L-98-255

Subject: Turkey Point Units 3 and 4  
Docket Nos. 50-250 and 50-251  
Supplemental Information-  
Request for Exemption - Fire Rating of  
Raceway Fire Barriers in Outdoor Fire Areas

Turkey Point Units 3 and 4  
Safe Shutdown Circuits for Selected Outdoor Fire Zones  
(Supplement to FPL Letter L-98-153)

ATTACHMENT 3 TO L-98-255    Page 1 of 4  
**RACEWAY/CABLE FUNCTION MATRIX**  
 TURBINE BUILDING RACEWAYS REQUIRING 1-HOUR RATED FIRE BARRIERS

PTN-M-97-052-004

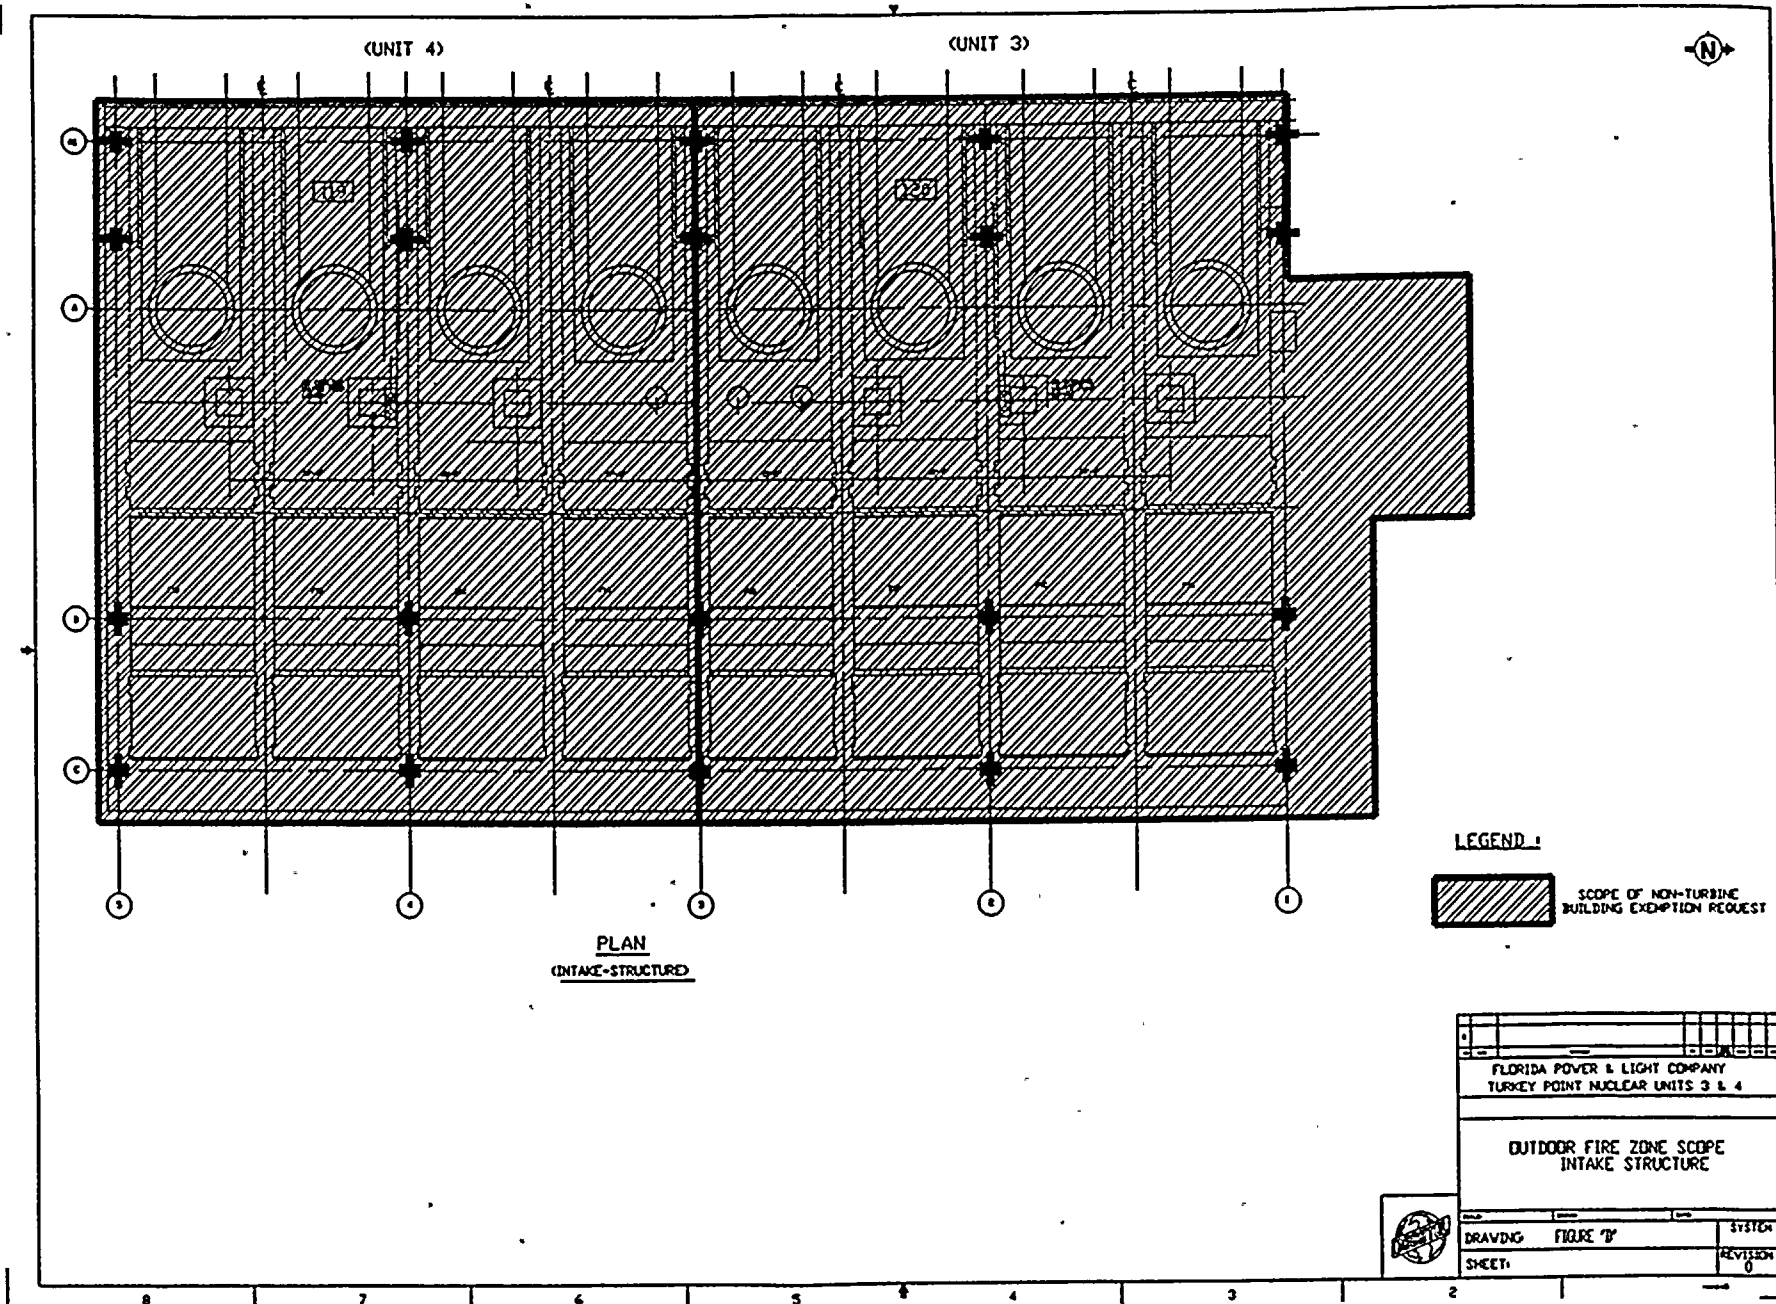
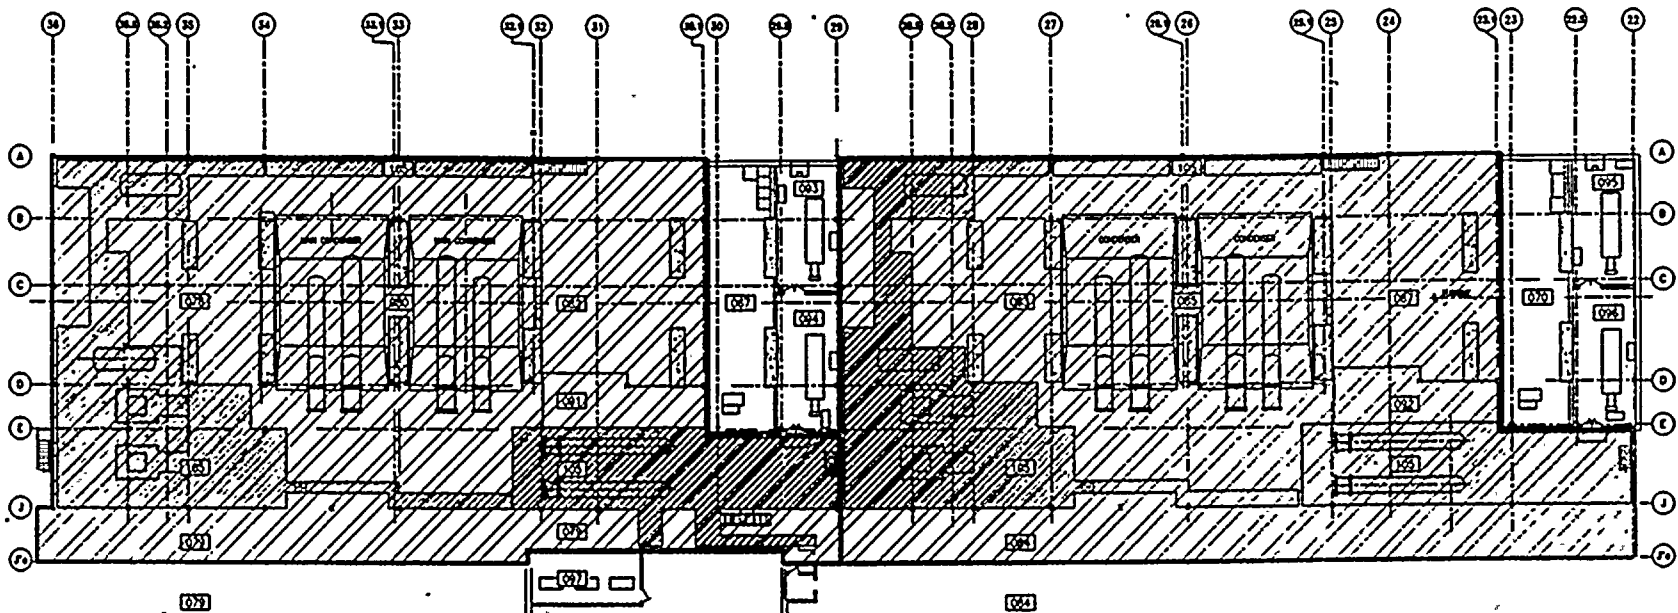
Based on discussions with the NRC staff during the September 14, 1998, meeting, the proposed scope of 1-hour fire rated barriers for protected raceways is expanded eastward from column line E inside the open turbine building. This expanded scope provides added protection in the zone of influence from a postulated fire in the condensate pump pits. Additional details are provided in the attached Turkey Point Drawing PTN-M-97-052-004, Sheets 1, 4 and 5, and the Raceway/Cable Function Matrix (Attachment 3).

1. 1-HOUR RATED FIRE SHIELDS WITH AUTOMATIC SPRINKLERS FROM COLUMN A TO E-1.
2. ELECTRIC, BATTERY FIRE SHIELDS INCLUDING 1-HOUR FIRE EXTINGUISHING SYSTEMS ARE TO BE UPGRADED WITH BURNING-LAG 770-1 (IN ACCORDANCE WITH SPECIFICATION 88-3.1.1, REVISION 1)
3. BATTERIES LOCATED BETWEEN 8'-0" WEST OF COLUMN C AND 10'-0" WEST OF COLUMN D SHAL REQUIRE FIRE SHIELDS WILL ALSO BE PROTECTED WITH THERMALITE STEEL SHIELDS. INSTALL SHIELDS IN ACCORDANCE WITH PG/M 97-002, REVISION 1, ATTACHMENT 6.
